Consultant	Wahib Medanat Consultant Engineer	Rep No.	11-16042022
Contractor	Derar Saraireh & Sons for Engineering & Contracting	Tender No.	(11/2019/USAID/SKEP/3/S) Schools for a Knowledge Economy Project (SKEP) - Phase (3) Package (1, 2)
Site Name	Um Al Dananir Basic Mixed School- Al Balqa	Day/ Date	Sat. 16/04/2022
Duration of Project	450 Calendar Days	Total Project Budget	9,789,417.840 JD

Visit Notes

(figure:16)

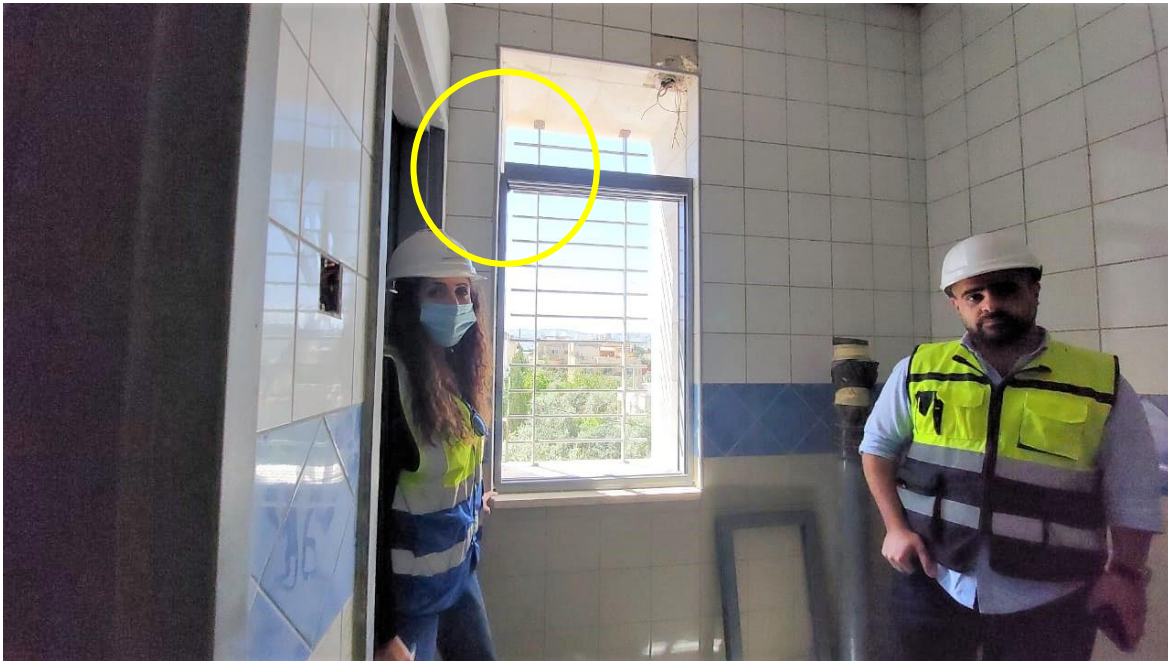
The team requested the Contractor to check the verticality of handles of the cabinets since one handle was observed not vertical. The Contractor was requested to perform all needed repairs to the cabinets in the kindergarten before preliminary handing over to the supervision site staff
